Multiple Sewershed Package 5
Solicitation Number: CO-00179
Job No.: 17-4551

ADDENDUM 3
SEPTEMBER 10, 2018

PROJECT LOCATION 4 EXISTING CONDITION & CONTROL PLAN

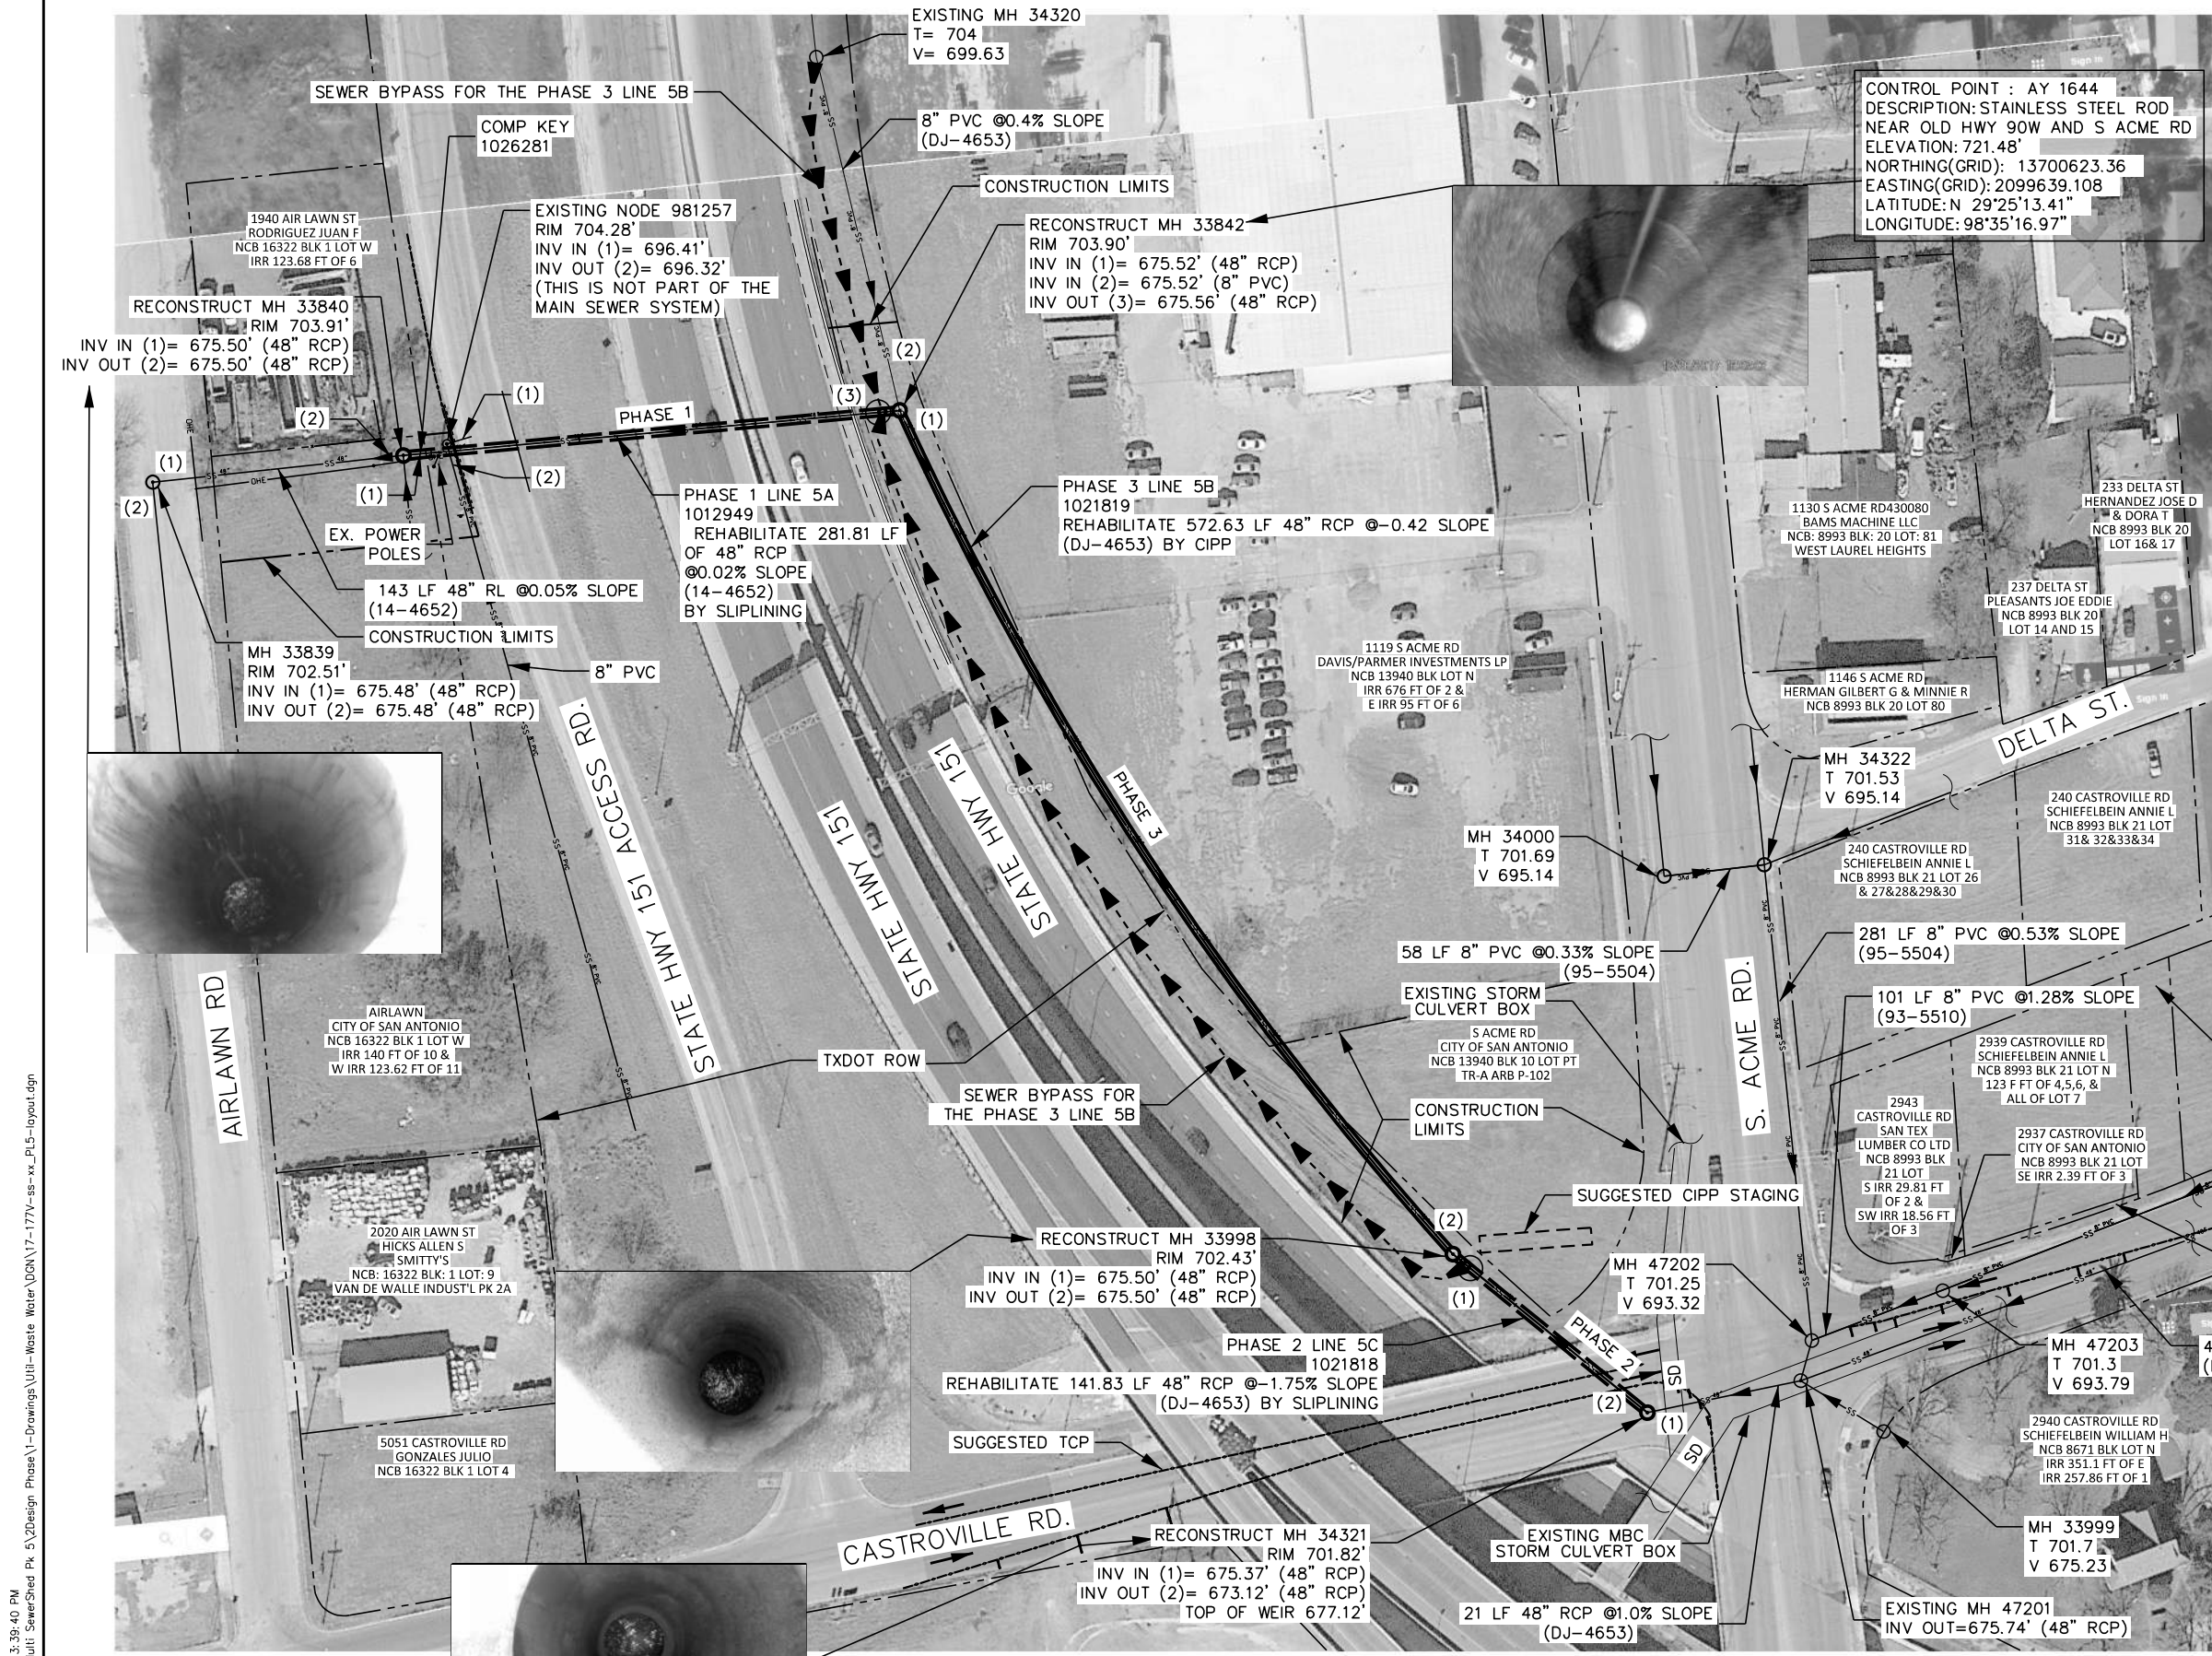
22. **Question:** At Project Location 4 on drawing sheet 16, there is a mill & overlay area shown. On the Sewer Bypass Crossing Layout detail in the upper right corner, it says the limits of this mill & overlay area are 33 feet minimum, but on the larger drawing, the crosshatched mill & overlay requirement extends much farther than the indicated 33 feet. Please clarify the dimensions of the mill & overlay area required at this project location.

Response: *The 33' dimension is referring to an existing trench line (unknown utility) found at the site. This dimension defines the northern limit of mill & overlay.*
